# UNITED STATES PATENT AND TRADEMARK OFFICE

APPLICATION NO.	FILING DATE	FIRST NAMED INVENTOR	ATTORNEY DOCKET NO.	CONFIRMATION NO.
10/672,140	09/26/2003	Michael B. Timmons	1153.066US2	8068
21186	7590	06/14/2006	EXAMINER	
SCHWEGMAN, LUNDBERG, WOESSNER & KLUTH, P.A. P.O. BOX 2938 MINNEAPOLIS, MN 55402			POPOVICS, ROBERT J	
			ART UNIT	PAPER NUMBER
			1724

<b>Office Action Summary</b>	<b>Application No.</b>	<b>Applicant(s)</b>	
	10/672,140	TIMMONS, MICHAEL B.	
	<b>Examiner</b>	<b>Art Unit</b>	
	Robert J. Popovics	1724

**DETAILED ACTION*****Claim Rejections - 35 USC § 103***

FIG. 1

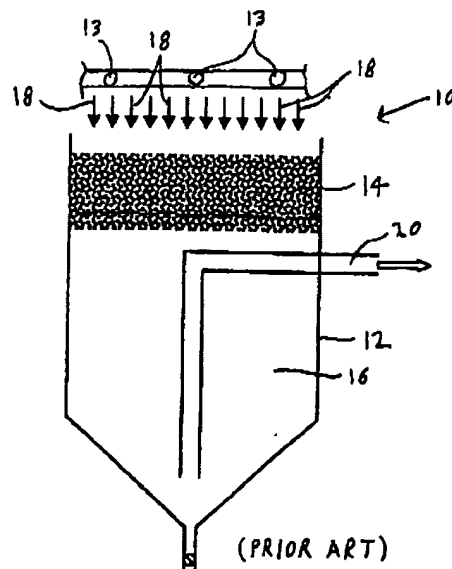
The system admitted to be "**prior art**" by Applicant fails to teach a division of the hydraulic loading area into a plurality of cells with smaller hydraulic loading areas. The issue to be decided is whether it would have been obvious for one skilled in the art to modify the system admitted to be prior art by dividing the hydraulic loading area into a plurality of cells with smaller hydraulic loading areas.

Both **Greeleaf (US Patent No. 3,312,348)** and **Schulz (US Patent No. 5,032,294)** disclose filters employing individual cells. See column 3, lines 20-30 of Greenleaf and Figure 4 of Schulz. In view of these disclosures, it would have been obvious to divide the hydraulic loading area of the system described as "prior art" by

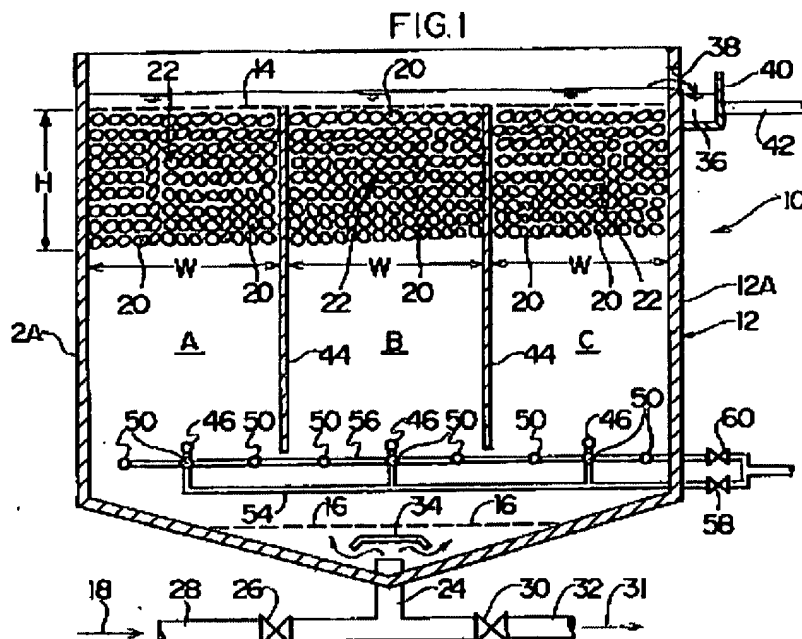
Applicant, into a plurality of cells. Such a modification would enable those skilled in the art to keep the majority of cells online, while individual cells are taken off line for periodic backwashing, routine maintenance and/or replacement of media. These advantages would have been readily apparent to those skilled in the art who had reviewed Greenleaf. See, for example, column 1, lines 45-50 and column 2, lines 55-70 of Greenleaf.

With respect to claims 6,7,11, 37 Claim 6 and 11 specify the cells to be ***"square-shaped,"*** while claim 7 specifies ***"wherein each cell has a hydraulic loading area less than 2.3 square meters."*** And claim 37 specifies the hydraulic loading area of the chamber to be greater than 4.6 square meters. The specific shape and size of the cells, absent a showing of unexpected results and/or criticality specifically associated therewith, are design parameters that would have been routinely selected, or optimized by one skilled in the art. Moreover, it is noted that the rectangular shape of the cells disclosed by Schulz is nearly square. Some skilled in the art might even refer to the cells disclosed in Figure 4 of Schulz as being ***"squared-shaped."***

Claims 1 and 2 are rejected under 35 U.S.C. 102(b) as being anticipated by **Schulz (US Patent No. 5,032,294)**. See Figure 4.

Claims 6 and 7 are rejected under 35 U.S.C. 103(a) as being unpatentable over **Schulz (US Patent No. 5,032,294)**. See Figure 4. Claim 6 specifies the cells to be ***"square-shaped,"*** while claim 7 specifies ***"wherein each cell has a hydraulic loading area less than 2.3 square meters."*** The specific shape and size of the cells, absent a showing of unexpected results and/or criticality specifically associated therewith, are design parameters that would have been routinely selected, or optimized by one skilled in the art. Moreover, it is noted that the rectangular shape of the cells disclosed by Schulz is nearly square. Some skilled in the art might even refer to the cells disclosed in Figure 4 of Schulz as being ***"square-shaped."***
